Reply to Reviewer Comments

Reviewer 1:

Fig. 3. Research methodology for processing and analysis of debris flow seismic signal.

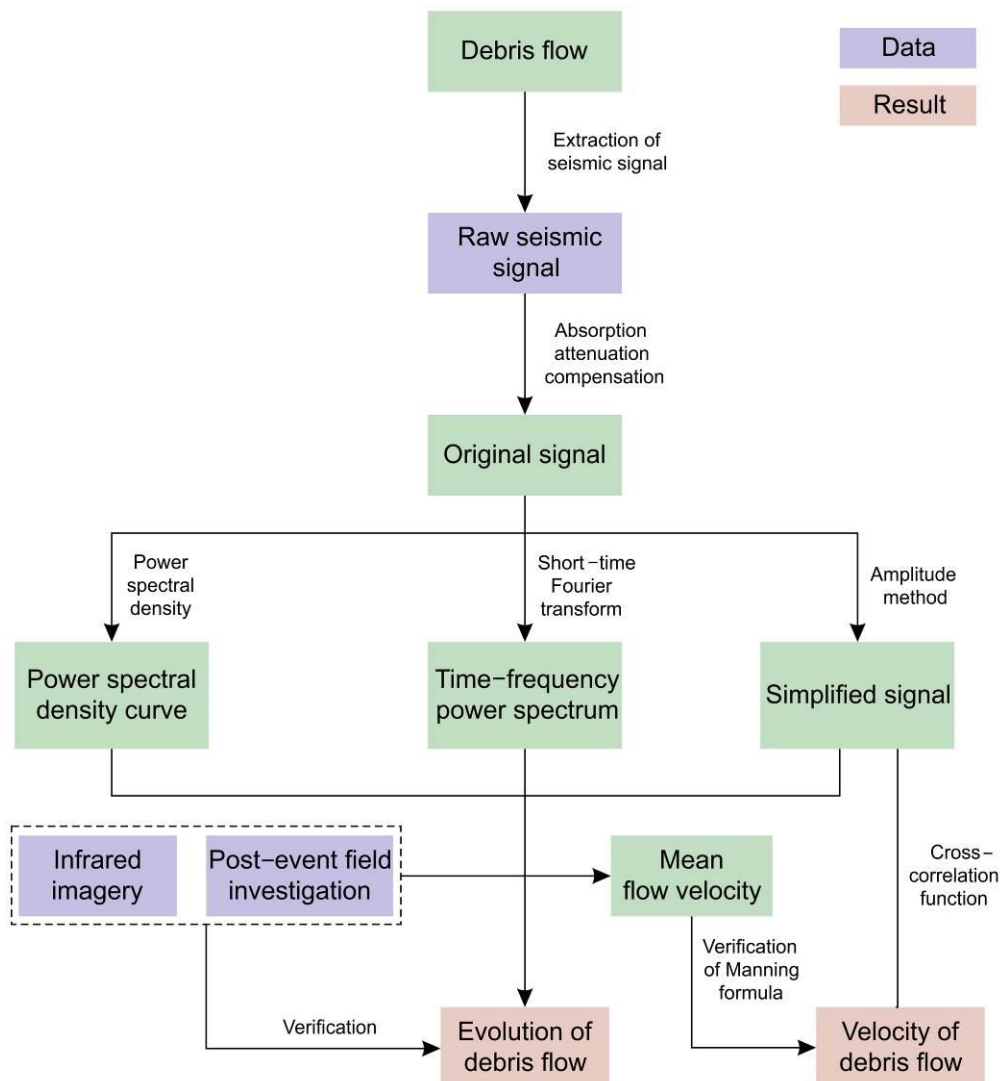
C16: The workflow is not clear in Figure 3. If I understand well, the “absorption attenuation compensation“ (consider changing the name to simply “attenuation compensation”) depends on the frequency, so you need to apply the STFT first. Besides, the PSD is deduced from the time frequency power spectrum, so the correct workflow should be, if I understand well, as in the following graph. The order of subsection in the Methodology section should reflect this ordering. Finally, if I’m correct you do not explain what the “amplitude method” is and what the “simplified signal” is.

R16: Thank you for the constructive advice. Actually, power spectral density curve, time-frequency power spectrum, simplified signal are obtained based on original signal, which differs from your workflow. We acknowledge the workflow is not clear to make you confused, so the workflow of Fig. 3 has been modified into the following graph after we changed the structure of the manuscript. And we start the section Methodology with a brief systematic introduction to this section to facilitate the reader’s understanding of our Methodology. This part has been modified, as follows:

To extract information on debris flow evolution, debris flow seismic signals were processed and interpreted by following the procedure in Fig. 3. Absorption attenuation compensation is first to be processed for each frequency of the extracted seismic signal of debris flow to restore the different energy loss caused by different propagation, which was aimed to obtain the seismic signal of debris flow that is not affected by sensors installation location. Then, the seismic spectrogram is from compensated seismic signal based on short-time Fourier transform, characteristic analysis of debris flow evolution has been done by computing power spectral density of keyframe and the absolute value of time-domain amplitude, the evolution analysis result has been verified based on infrared imagery and post-event field investigation. Finally, the maximum velocity of debris flow has been estimated by computing the absolute seismic amplitude of different monitoring stations based on the cross-correlation function, which has been verified by the Manning formula. The key steps are outlined below in Fig. 3. Amplitude method in this figure is used to get the absolute value of time-domain amplitude in this figure. After this method, the signal processed by us is called a simplified signal.

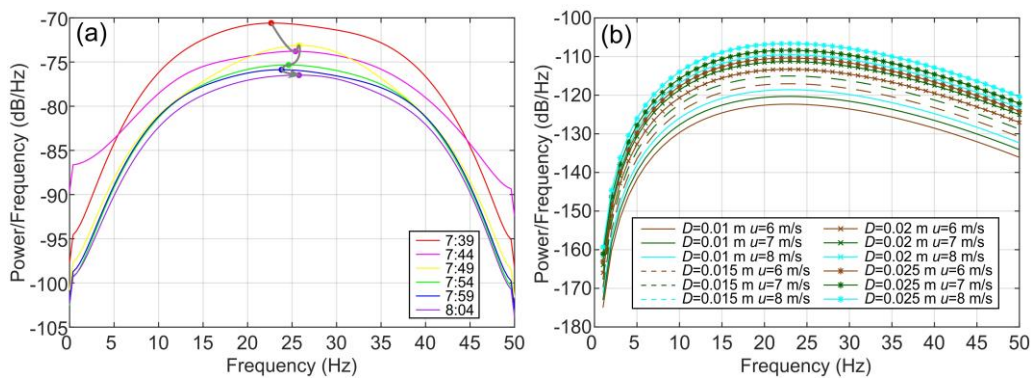
C55: 1.447 to 457: Figure 10 does not illustrate very well what you say in this paragraph, especially the temporal variations you mention. A plot with the temporal variations of the PSD would be more appropriate.

R55: Thanks a lot for the constructive comment. We will follow your constructive suggestion if we choose video to monitor debris flow subsequently. Because we used camera with 5-min interval shooting, it is better to draw a plot with the frequency variations of the PSD to achieve semi-quantitative analysis of PSD.

Fig. 4. Cross-sections of Fotangbagou gully showing maximum water level used in calculation of mean velocity by the Manning formula. (a) Monitoring station 1; (b) Monitoring station 2.

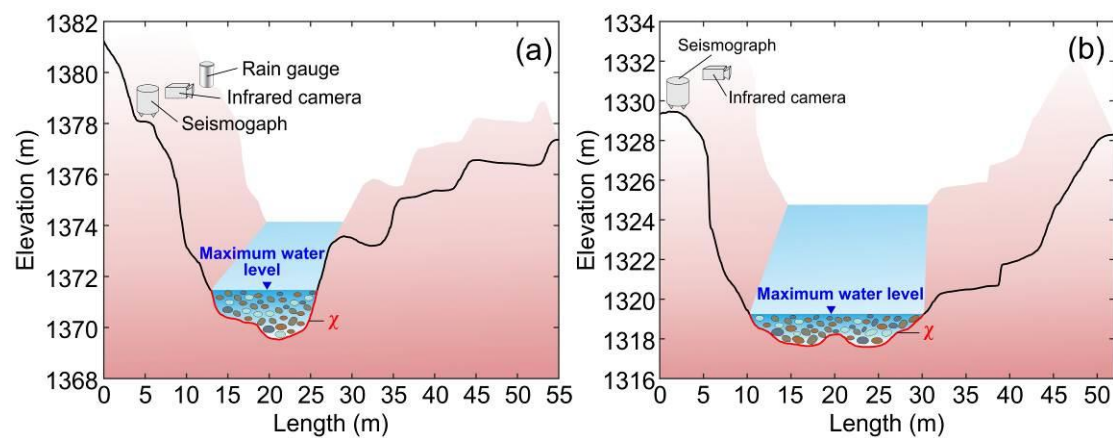
C24: 1.231-232: You must explain more clearly what J and R are, explain how you compute them, and illustrate it on a figure (e.g. on current Figure 13 that could be placed in section 3.3).

R66: Thank you for the useful advice. χ can be used to estimate summation of bed length and lateral depth of the channel wetted by debris flow in the cross-section. The sentence above has been modified in Section 3.3. The definition of the wet perimeter is shown in Fig. 4.

Fig. 1. Overview of the study area. (a) Location of the study area within China; (b) The two study catchments, Ergou and Fotangbagou, on the Minjiang River, Wenchuan, Sichuan, China.

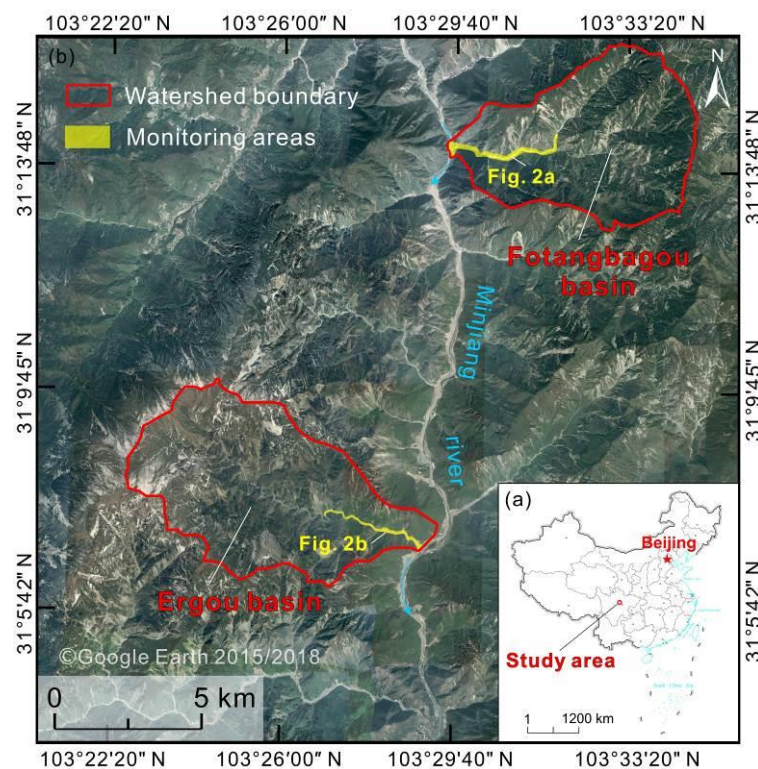
C79: Figure 1: You should simplify the legend, especially as some labels are repeated (e.g. Granite). Consider adding a topographic map. The insert (a) is small and the satellite imagery is visible behind, you should improve that. Explain in the legend what the yellow lines are.

R79: Thank you so much for the comments. We have changed size of subplot (a) and (b) to solve the problem mentioned by you in this figure. Two topographic maps were added in Figure 2. The subplot (c) has been deleted. It has been modified, as follows:

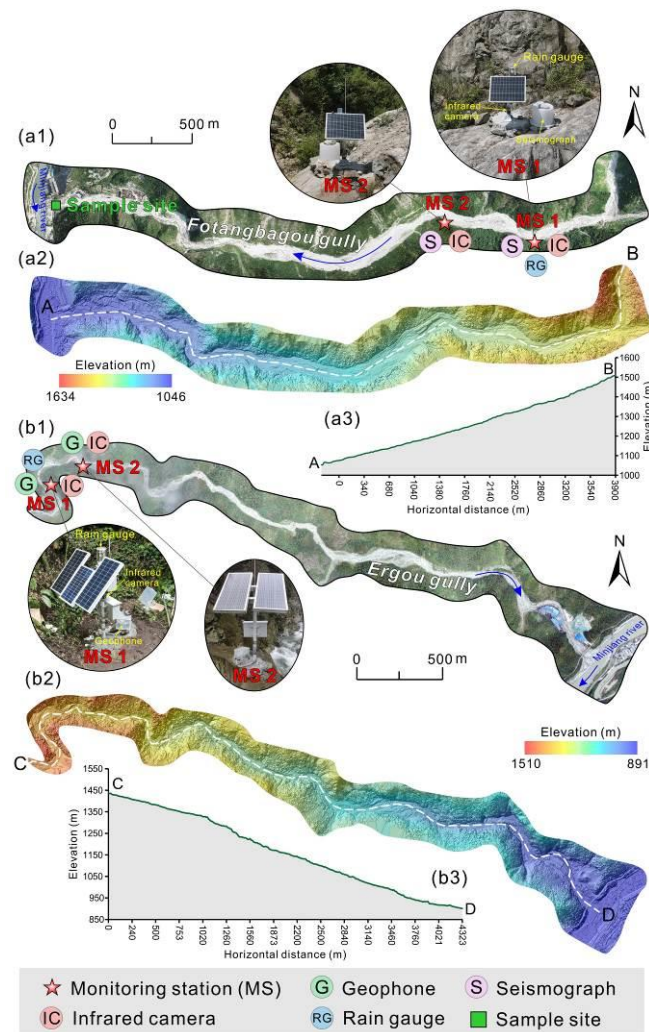
C80: Figure 2: I'm not sure a picture of all stations is necessary. You should add a Digital Terrain Model map for the two gullies if you have one. A longitudinal profile could also be helpful.

R80: We thank the reviewer for this comment. We have added two Digital Terrain Model maps for the two gullies. It has been modified, as follows:

Fig. 3. Research methodology for processing and analysis of debris flow seismic signal.

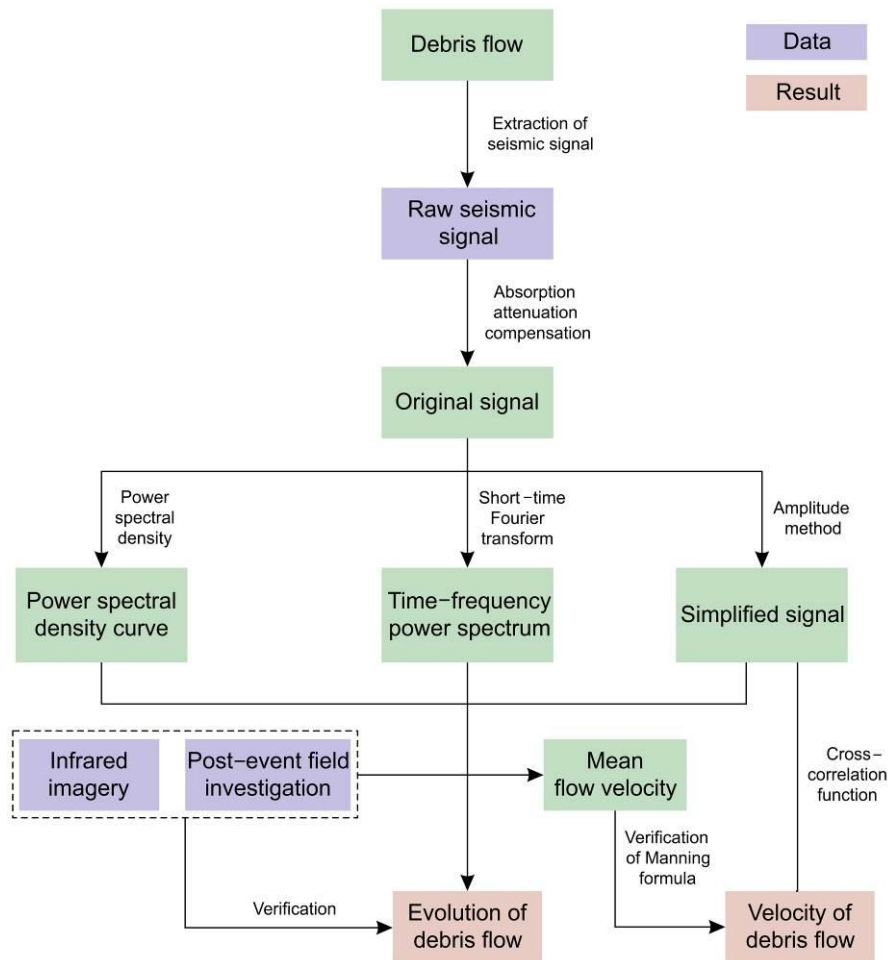
C81: Figure 3: “Infrared imagery” only during the night! For “amplitude method” and “simplified signal”, it is not clear what it corresponds to in the methodology presented in the main body of the article. Don’t you estimate the maximum flow velocity from the seismic signal also? Be more specific when you mention “scale of the debris flow”, do you mean discharge? Volume? See also the first specific comment for the Methodology section.

It has been modified to explain Fig. 3, as follows:

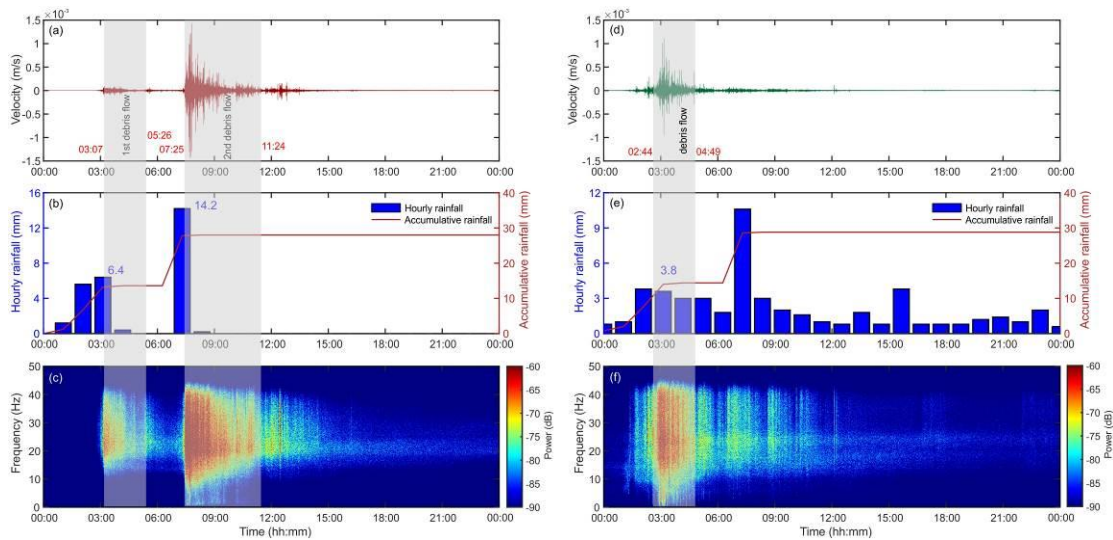
C82: Figure 4: You should display the alleged start and end time of all three events to improve clarity. In a and c, the high amplitudes exceed the plot limit. Is it only a representation issue, or is the signal saturated? In the legend of (a), you say that there's only the second debris flow, but aren't there two?

C83: Figure 5: You could add the seismic signals in the background, or at least the beginning and end time of all three events. The link with the precipitations would be more apparent.

R82: Thank you for your constructive comments. The alleged start and end time of all three events have been added in this figure. It is representation issue for the high amplitudes to exceed the plot limit. There is an error in the legend of (a), it has been modified into "raw seismic from Fotangbagou gully debris flow at station 1". It has been modified, as follows:

R83: We totally agree with the reviewer’s suggestion. This figure has been combined with Figure 4 in the first version. The beginning and end time of all three events have been added in the figure.

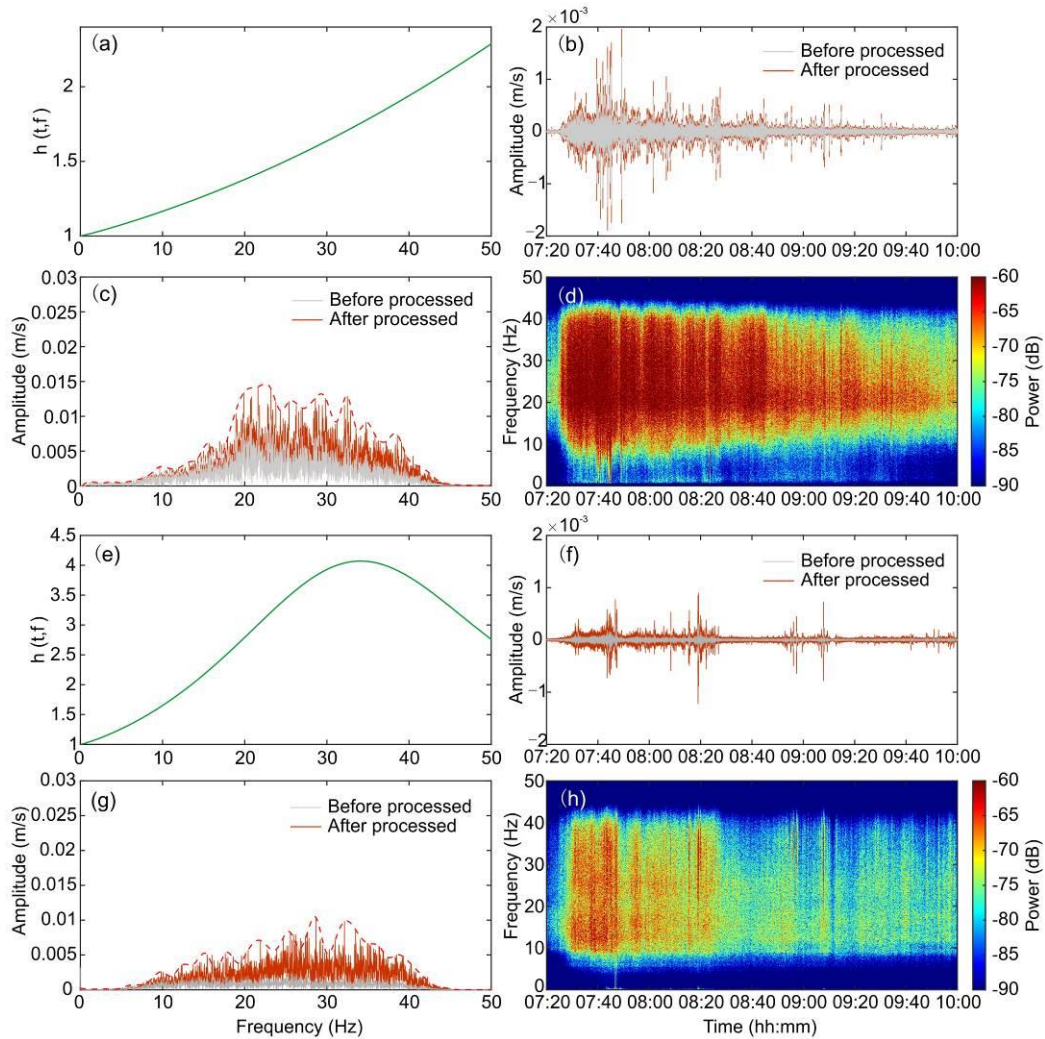
C84: Figure 6 and 7: Figure 7 use elements already present in Figure 6. Thus I would only display the damping factor and PSD in Figure 6. The “simplified signal” could also be displayed in Figure 7a and 7b. In the legend of Figure 6d, I think it is station 1, not station 2.

R84: Thank you for your professional comment. Figure 7 in the first version has been deleted because this figure has appeared in Figure 6 in the first version. In the legend of Figure 6d, it is station 1, it has been modified into “Time-frequency domain energy spectrum for monitoring station 1”. It has been modified, as follows:

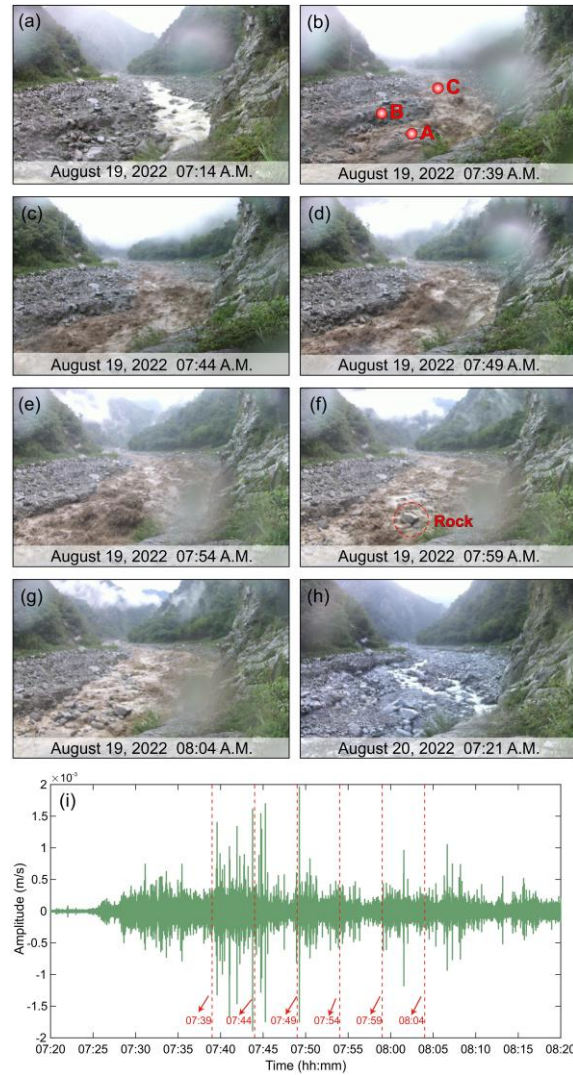
C85: Figure 8: Picture are very small, it is difficult to see the different behaviours of the debris flow at each time.

R85: Thanks a lot for the constructive comment. Pictures have been arranged to improve their clarity. It has been modified, as follows:

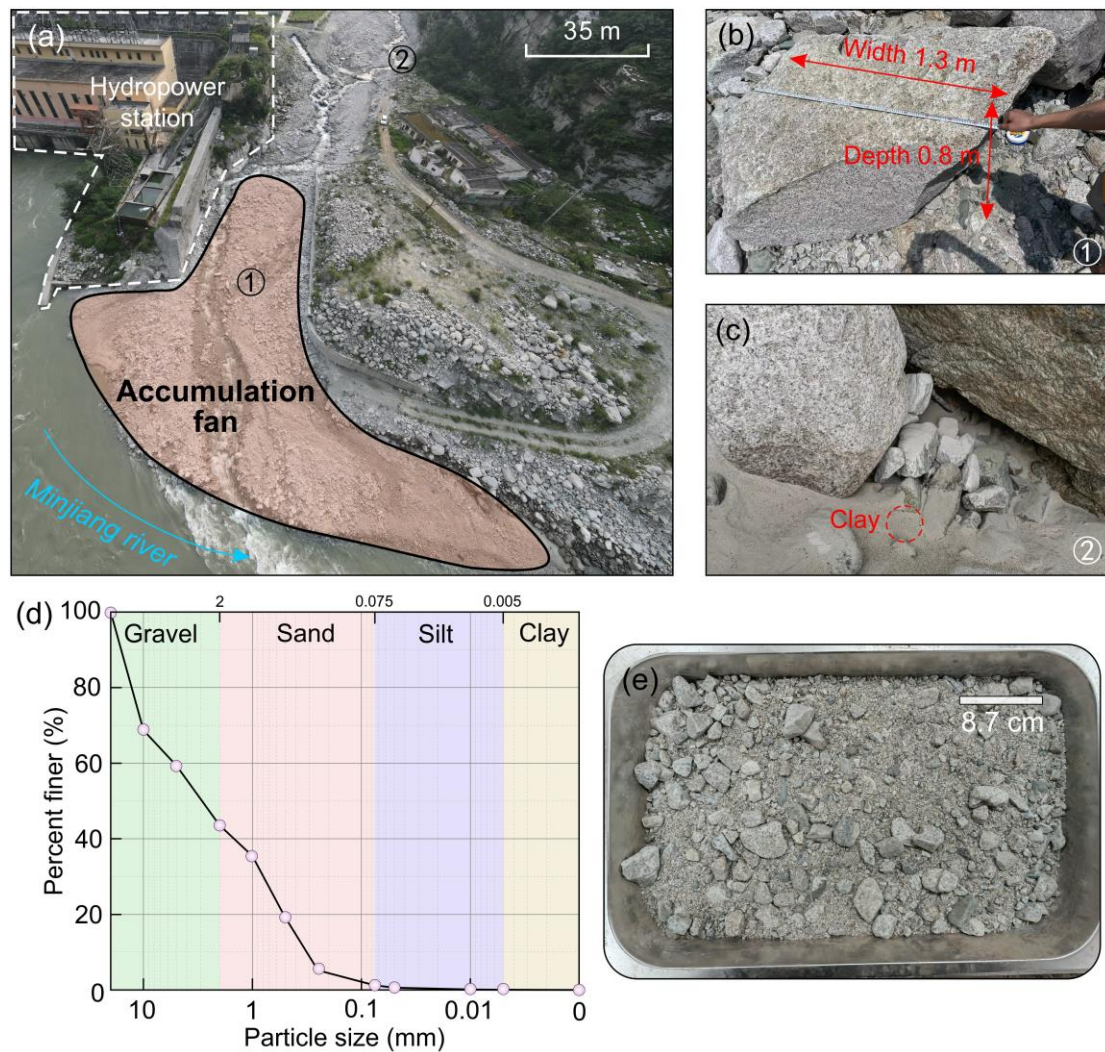
C86: Figure 9: “viscous particle” is not an appropriate term. In (d), you could add the granulometric ranges associated to gravel, sand, silt and clay.

R86: Thank you for the useful advice. “Viscous particle” has been modified into “clay”. Range of gravel, sand, silt and clay has been added in subplot (d). It has been modified, as follows:

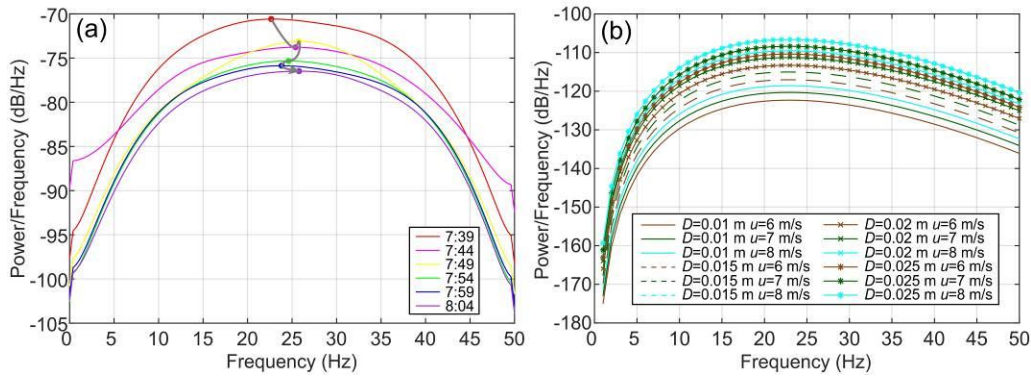
C87: Figure 10: This plot is not easy to interpret. It must be improved / changed to better illustrate and support the statements made in the main body of the article. L.463 you mention “PSD maximum”, it is not clear what this maximum corresponds to (maximum over what?).

R87: We thank the reviewer for this helpful comment. This figure has been divided into two figures. It would make the figures easy to interpret. It has been modified, as follows:

Fig. 4. Cross-sections of Fotangbagou gully showing maximum water level used in calculation of mean velocity by the Manning formula. (a) Monitoring station 1; (b) Monitoring station 2.

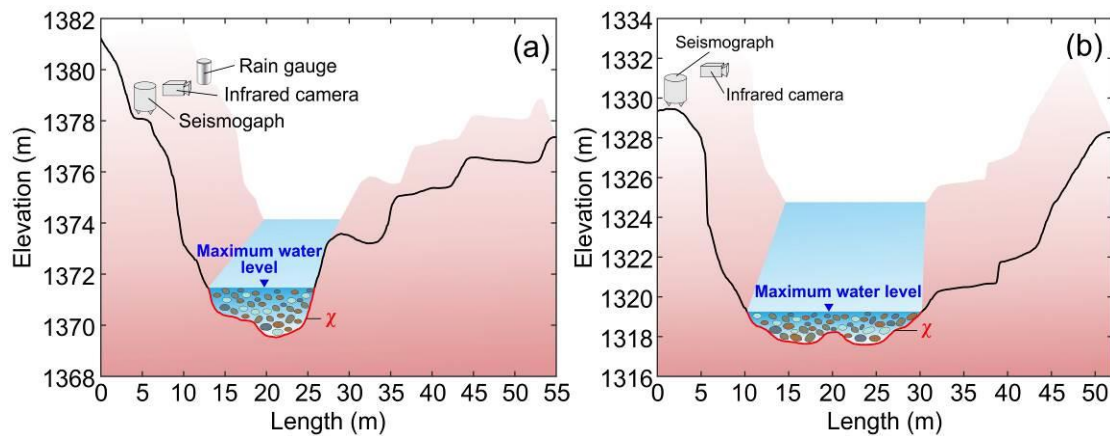
C89: Figure 13: This figure should be in the Methodology section, and should be improved to illustrate how the different parameters of the Manning formula are computed.

R89: Thank you so much for the comments. This figure has been moved to the Methodology section and added illustration of wet perimeter χ . It has been modified, as follows:

Fig. 1. Overview of the study area. (a) Location of the study area within China; (b) The two study catchments, Ergou and Fotangbagou, on the Minjiang River, Wenchuan, Sichuan, China.

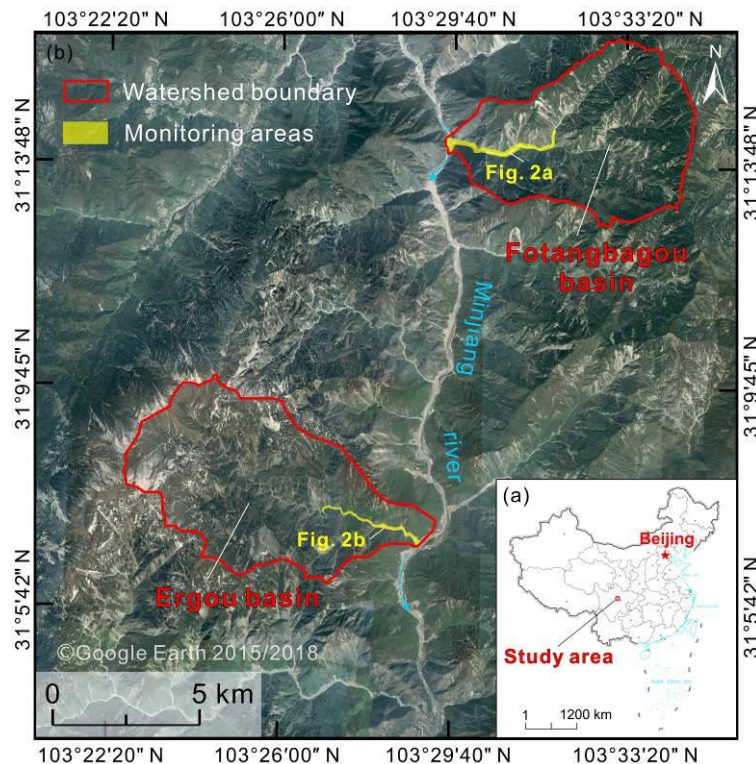
C32: Figure 1: I'm not sure that Figure 1c is necessary, since you do not mention the geology of the area with this precision. If you remove the panel and all the legend, Figure 1a and 1c could gain some space. In the caption of the figure, say that the catchments of interest are in red. I don't get Google Earth 2015/2018: why these two years?

R32: We thank the reviewer for this comment. We also think Figure 1c is unnecessary, so Figure 1c, the panel and all the legend were deleted. The catchments of interest in red also have been explained in legend. Satellite images in 2015 and 2018 are the newest available for the study area. Because the area is too broad, satellite images of this area in 2015 or 2018 are incomplete. Thus, Figure 1b is drawn from the combination of two satellite images of 2015 and 2018. The figure has been modified, as follows:
